NOTICE OF ADDENDUM
ADDENDUM NO. 3
City of Madison, Engineering Department

CONTRACT NO. 8981
METRO TRANSIT PHASE 3A – MAINTENANCE AND DRIVER FACILITY IMPROVEMENTS

This addendum is issued to modify, explain or correct the original Drawings, Specifications, or Contract Documents marked as *Metro Transit Phase 3A–Maintenance and Driver Facility Improvements, City of Madison, Contract #8981, as issued on April 8th, 2021* and is hereby made a part of the contract documents.

1 FIRST FLOOR REFLECTED CEILING PLAN - AREA A
1/8" = 1'-0"

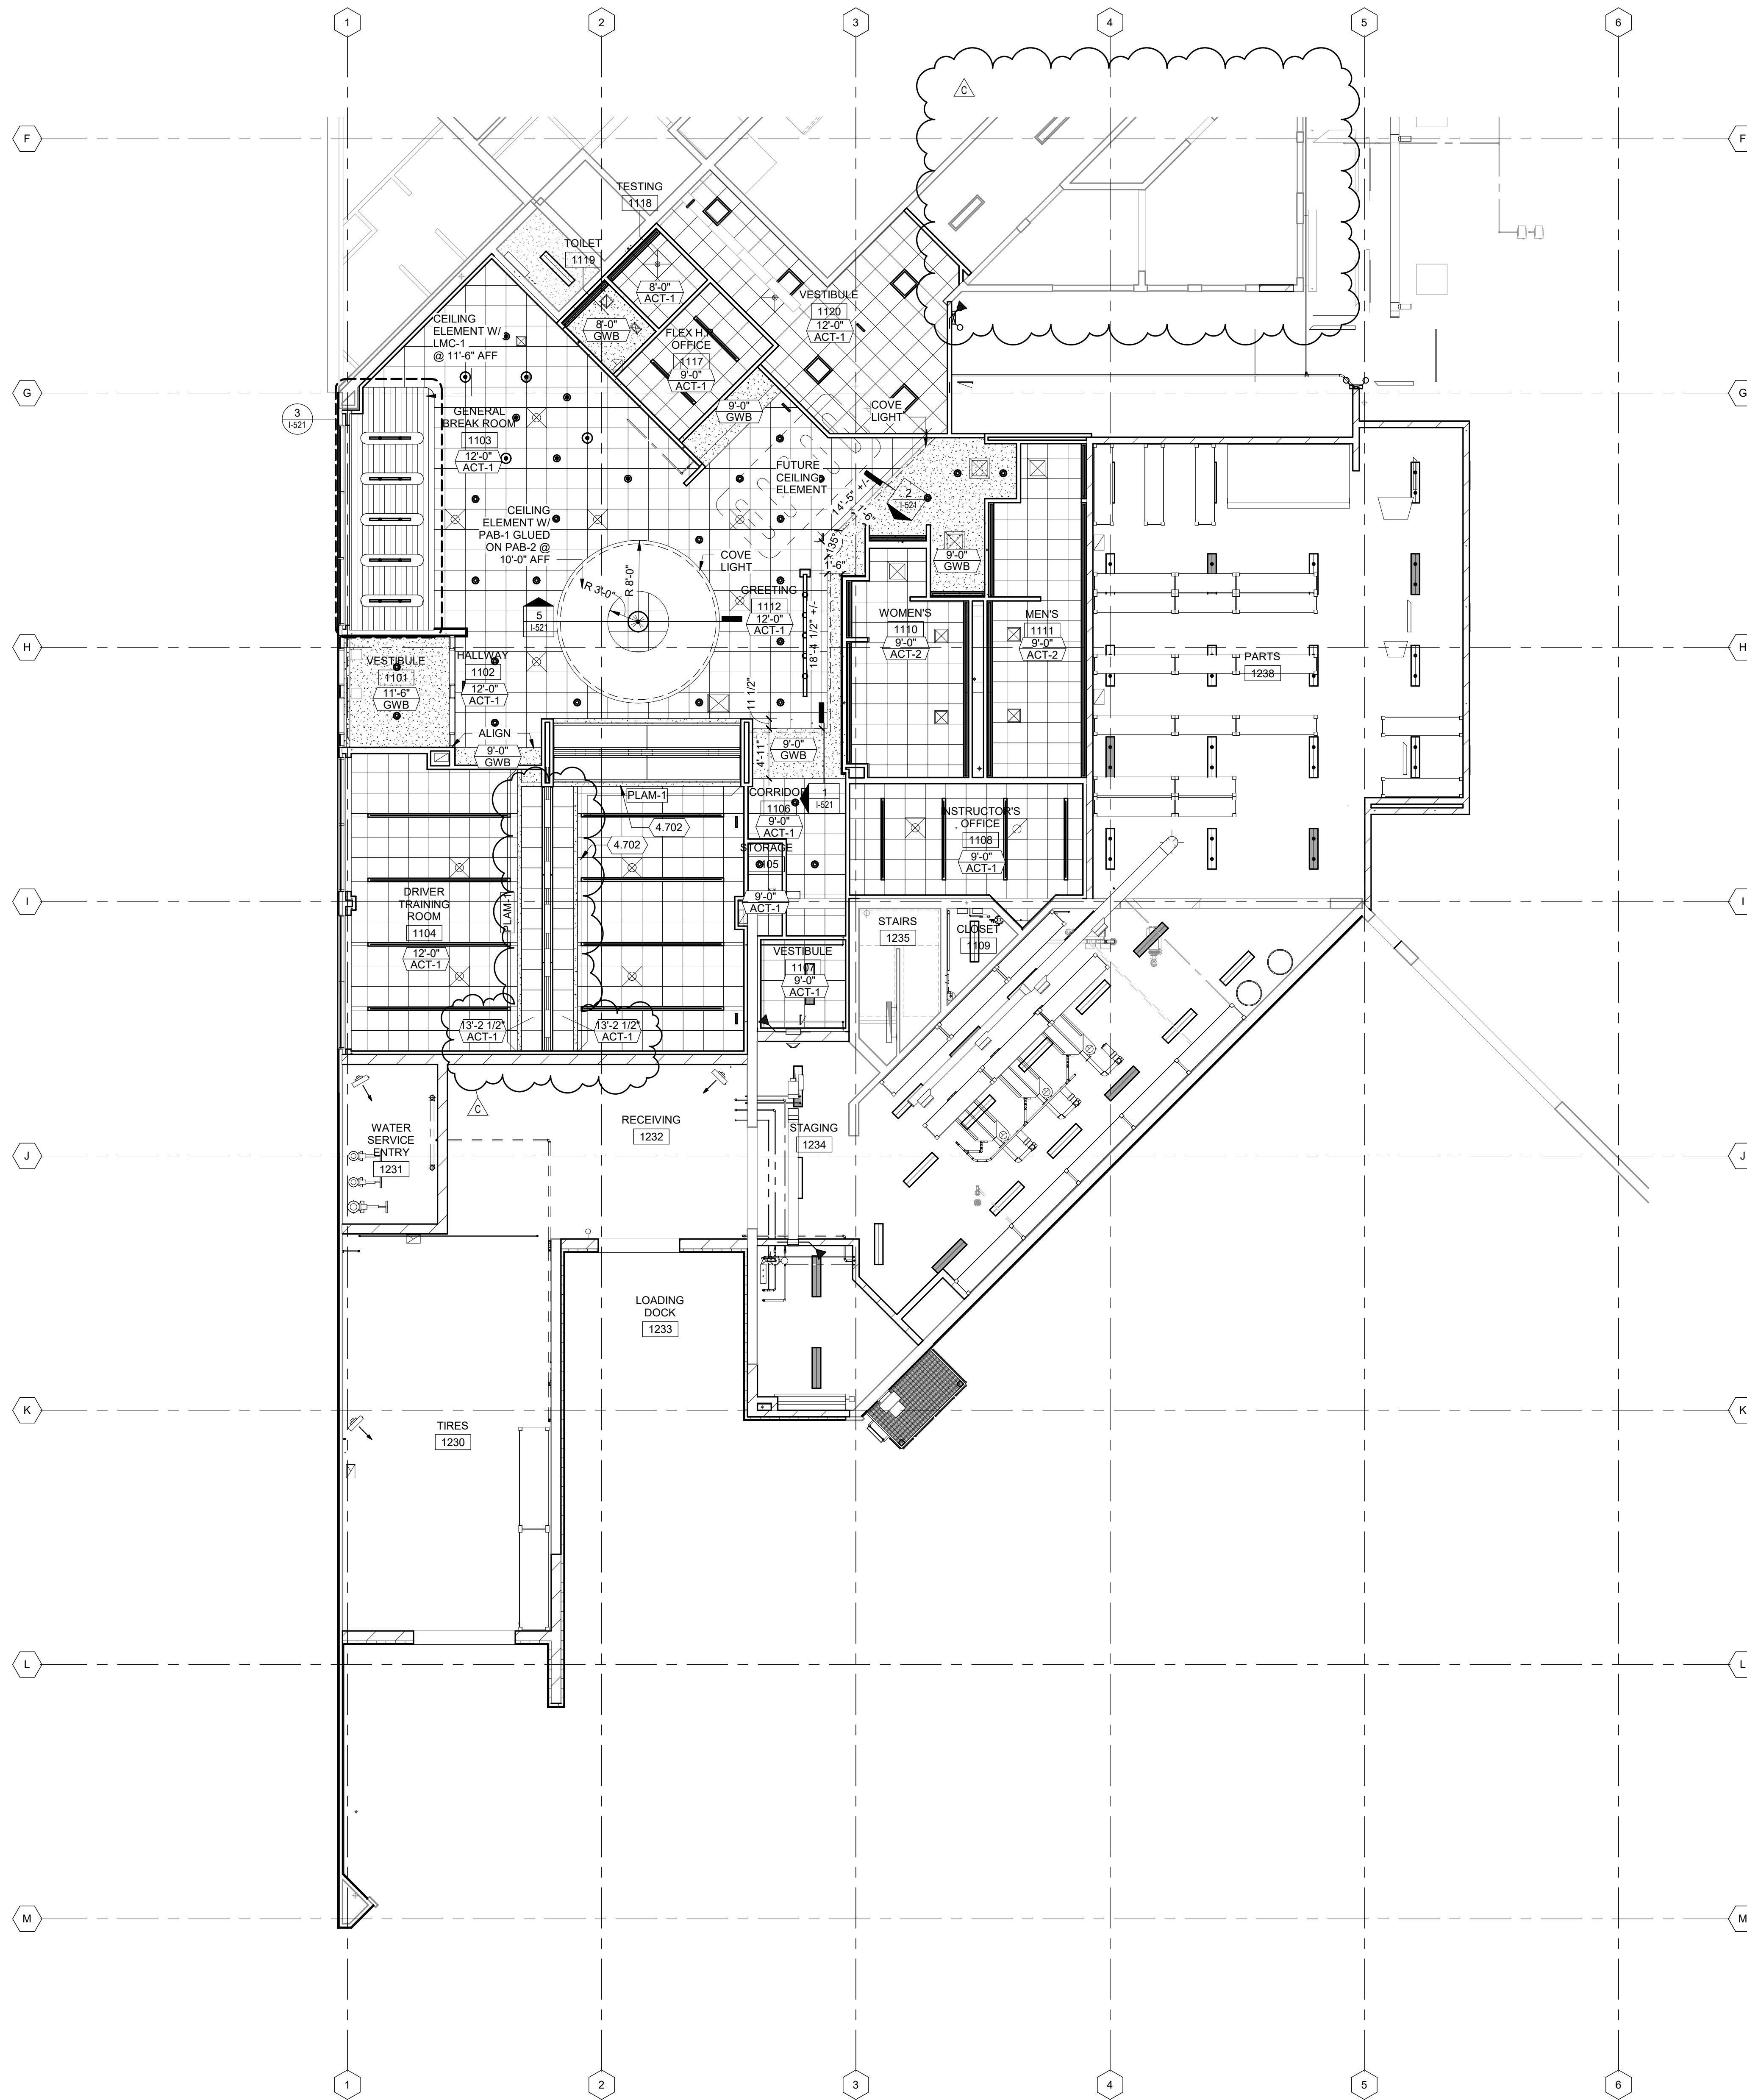
- ii. Drawing I-121A (attached);
 - Remove all existing ceiling hatches from areas outside of work scope.
 - Add ACT-1 at 13'2 1/2" A.F.F. on both sides of operable vertical partition in Driver Training Room 1104.

2 CHAIN LINK FENCE TYP
1/2" = 1'-0"

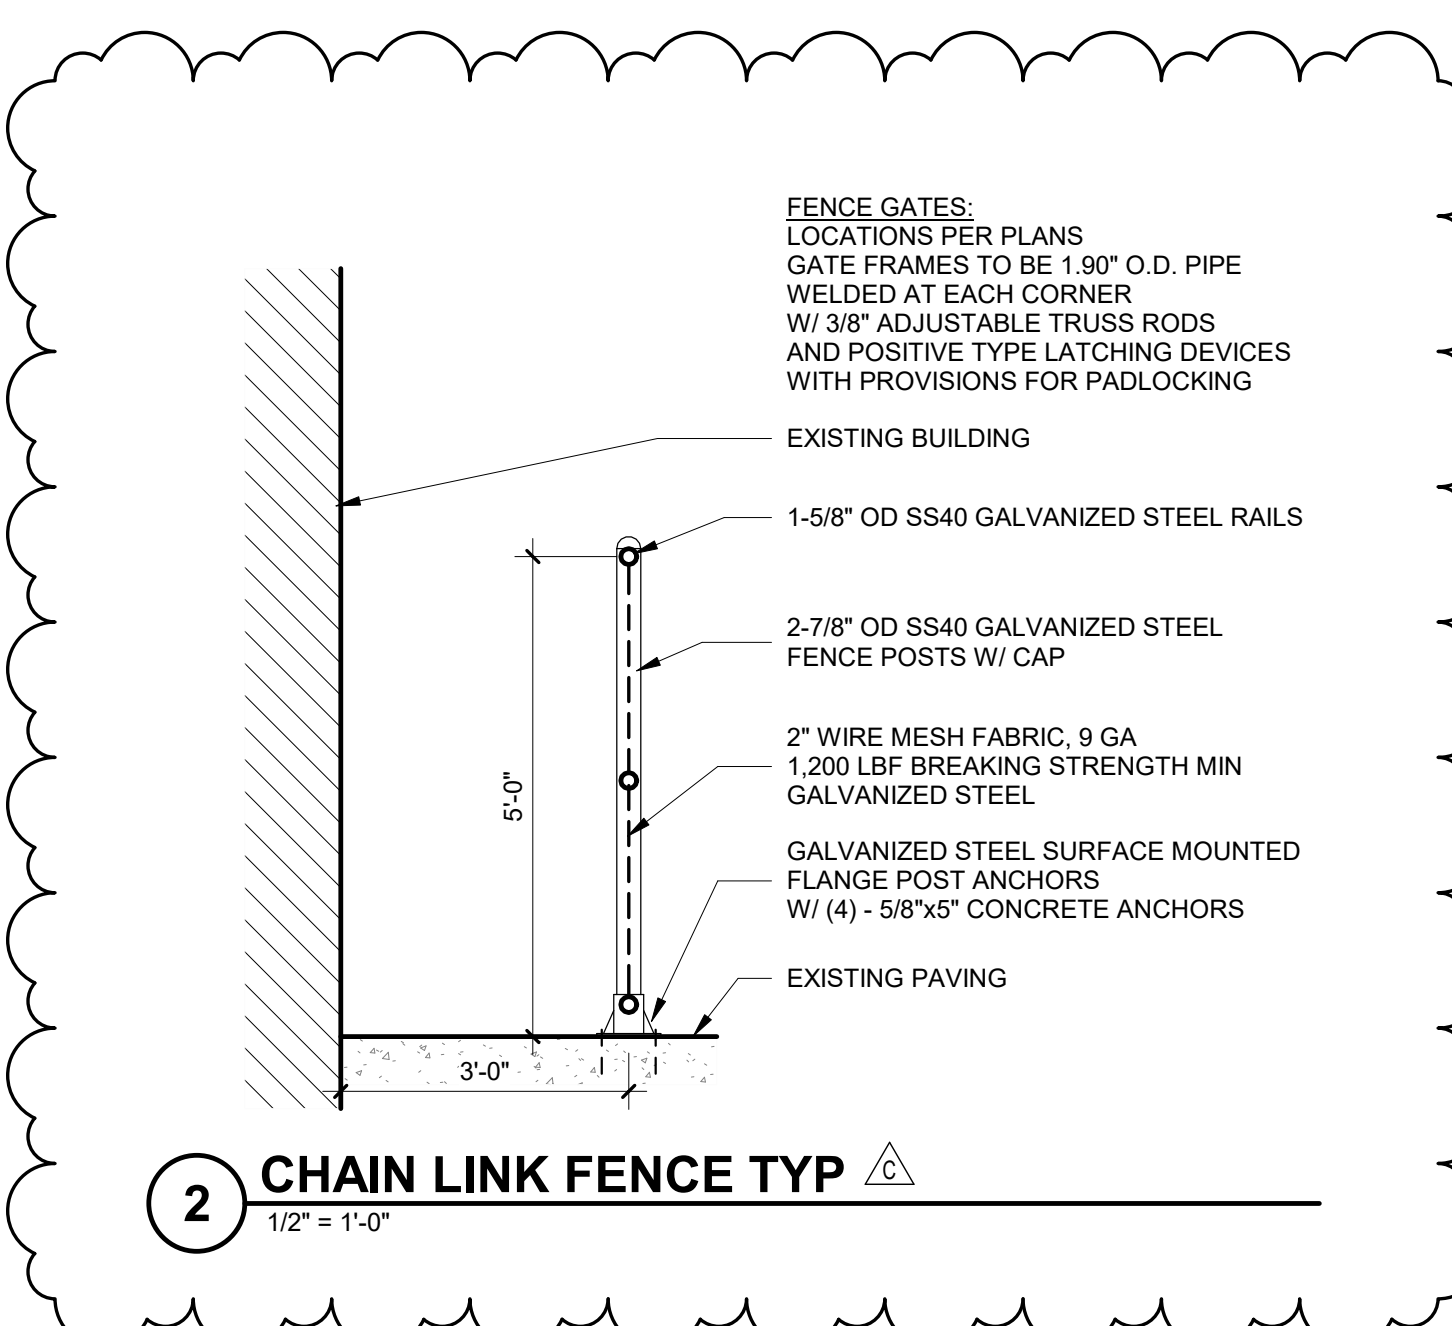
- I. On sheet QD-101A note at 1.L line there is a note that states to “Demo Existing Flammable Tank Storage Construct Matching Chain Link Fence Enclosure at Location Per Equipment Plans”. There is also a mark note of #123 which just states flammable tank storage. We are unable to find “...at location per equipment plans” per the stated note on equipment plans or any reference on architectural plans. Please clarify what the flammable tank storage is, what size it is to be, what materials it is comprised of, and provide a specification section for chain link fence/posts if that is part of the storage construction.

- i. Existing flammable tank storage (denoted by #123 on sheet QD101A) is a chain link fence enclosure, and shall be demolished. A new flammable tank storage enclosure shall be constructed at the location shown on sheet Q101A, also denoted by #123. See sheet Q101A for typical fencing detail and enclosure layout. Material from the existing chain link fence

- i. Drawings Q-101A (attached), provide fenced flammable storage area as shown.
